**World Forum for Harmonization of Vehicle Regulations****Working Party on Noise and Tyres****Seventy-sixth session**

**Tyres: UN Regulation No. 117 (Tyre rolling resistance, rolling noise and wet grip)****Proposal for the 04 series of amendments to UN Regulation  
No. 117****Submitted by the experts from the European Commission\***

### Examples of separate Regulation No. 117 approval marks

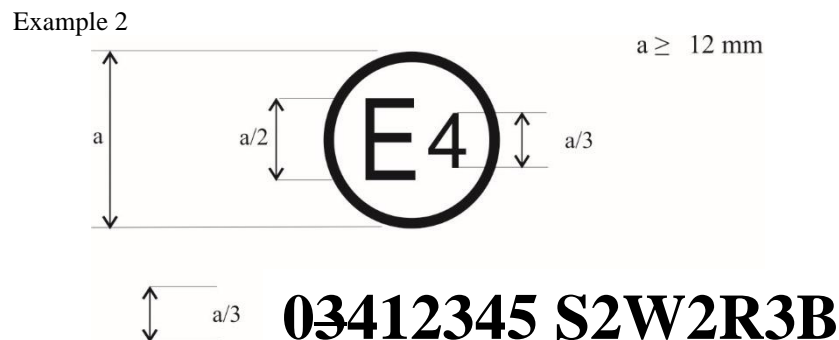
The above approval mark, affixed to a pneumatic tyre shows that a tyre concerned has been approved in the Netherlands (E 4) pursuant to Regulation No. 117 (marked by S2 (rolling sound at stage 2) only), under approval number 03412345. The first two digits of the approval number (034) indicate that the approval was granted according to the requirements 034 series of amendments to this Regulation.

The above approval mark shows that the tyre concerned has been approved in the Netherlands (E 4) pursuant to Regulation No. 117 (marked by S2 (rolling sound at stage 2) W2 (wet adhesion of tyres in new state **at stage 2)**, and R23 (Rolling resistance at stage 23) and B (wet adhesion of tyres in worn state)) under approval number 03412345. The first two digits of the approval number (034) indicate that the approval was granted according to the requirements of the 034 series of amendments to this Regulation.

Example 1

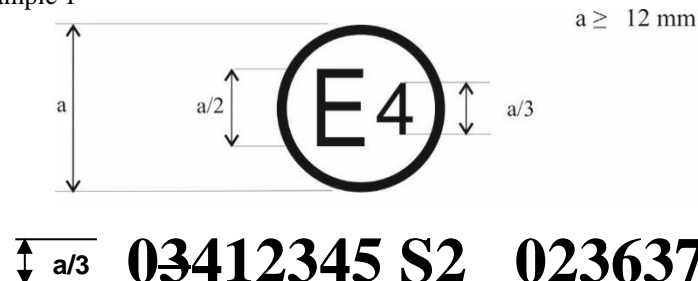
The above approval mark shows that the tyre concerned has been approved in the Netherlands (E 4) pursuant to Regulation No. 117 (marked by "S2" (rolling sound at stage 2)), under approval number 03412345 and Regulation No. 30, under approval number 0236378. The first two digits of the approval number ("034" and "02") indicate that the approval was granted according to the 034 series of amendments and the approval pursuant to UN Regulation No. 30 according to the 02 series of amendments.

Example 2

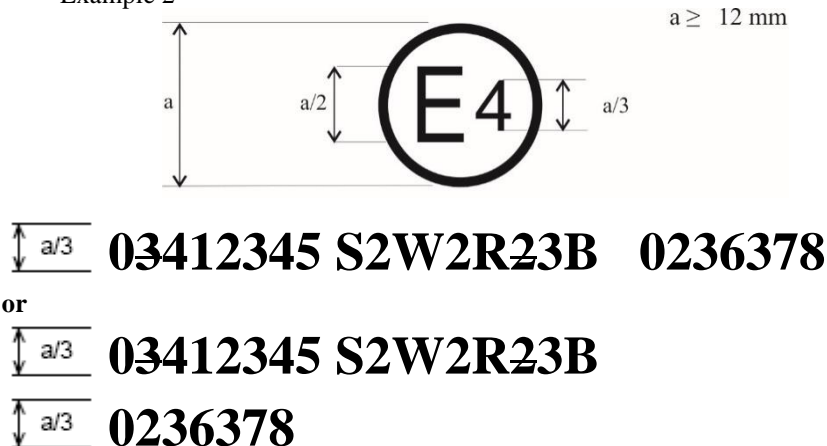
The above approval mark shows that the tyre concerned has been approved in the Netherlands (E 4) pursuant to Regulation No. 117 (marked by "S2W2R23B" (rolling sound emission at stage 2, wet adhesion of tyres in new state **at stage 2**, rolling resistance at stage ~~2~~**3** and wet adhesion of tyres in worn state)), under approval number 0312345 and UN Regulation No. 30 under approval number 0236378. The first two digits of the approval numbers ("034" and "02") indicate that the approval pursuant to UN Regulation No. 117 was granted according to the 034 series of amendments and the approval pursuant to UN Regulation No. 30 according to the 02 series of amendments.

Example 3

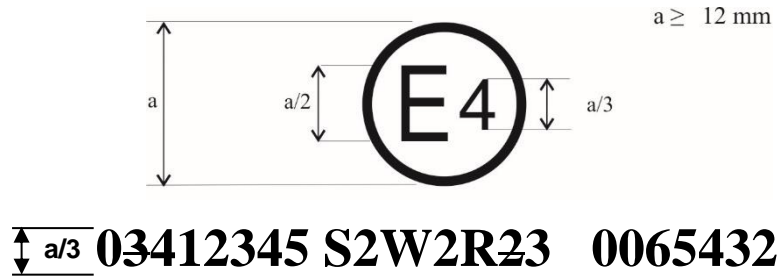
The above approval mark shows that the tyre concerned has been approved in the Netherlands (E4) pursuant to UN Regulation No. 117 (marked by "S2W2R23" (rolling sound emission at stage 2, wet adhesion of tyres in new state **at stage 2** and rolling resistance at stage 23)), under approval number 03412345 and UN Regulation No. 54 under approval number 0065432. The first two digits of the approval numbers ("034" and "00") indicate that the approval pursuant to UN Regulation No. 117 was granted according to the 034 series of amendments and the approval pursuant to UN Regulation No. 54 according to its original form.

Example 1

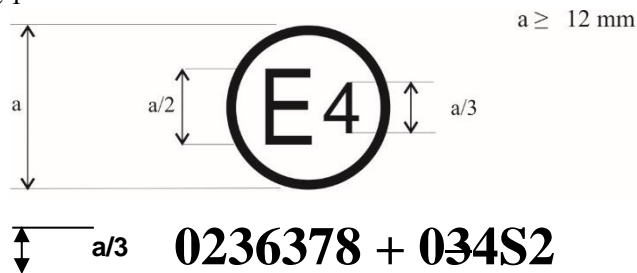
The above approval mark shows that the tyre concerned has been approved in the Netherlands (E4) pursuant to UN Regulation No. 30 according to its 02 series of amendments (indicated by the first two digits of the approval number, "02") under approval number 0236378. It is also marked by "+ 034S2" which indicates that the tyre was also approved pursuant to UN Regulation No. 117 (034 series of amendments) for S (rolling sound emission at stage 2).

Example 2

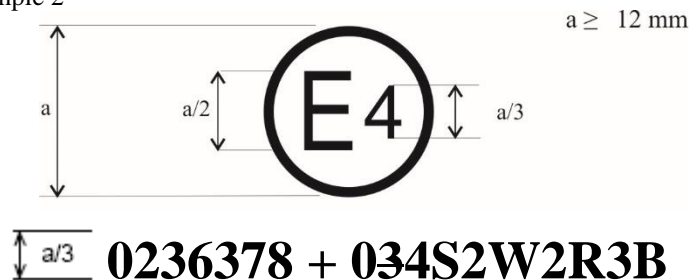
The above approval mark shows that the tyre concerned has been approved in the Netherlands (E4) pursuant to UN Regulation No. 30 according to its 02 series of amendments (indicated by the first two digits of the approval number, "02") under approval number 0236378. It is also marked by "+034S2W2R23B" which indicates that the tyre was also approved pursuant to UN Regulation No. 117 (034 series of amendments) for S (rolling sound emission at stage 2) W (wet adhesion of tyres in new state at stage 2), R (rolling resistance at stage 23) and B (wet adhesion of tyres in worn state).

### Extensions to combine approvals issued in accordance with Regulation No. 117

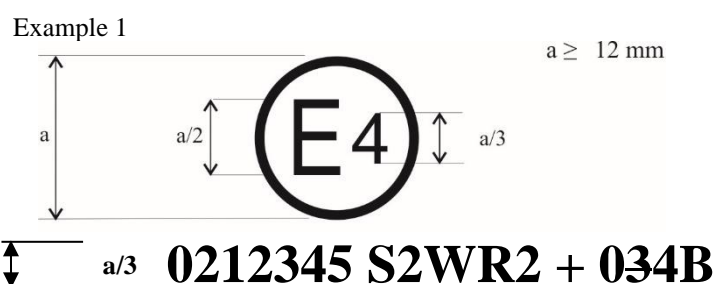
The above approval mark shows that the tyre concerned has been initially approved in the Netherlands (E4) pursuant to UN Regulation No. 117 and the 02 series of amendments under approval number 0212345. The marking is complemented by S2WR2 (rolling sound emission at stage 2) W (wet adhesion of tyres in new state) and R (rolling resistance at stage 2). The "034B" preceded by "+" indicates that it has had its approval extended under UN Regulation No. 117 and 034 series of amendments to wet adhesion of tyres in worn state based on separate certificate."
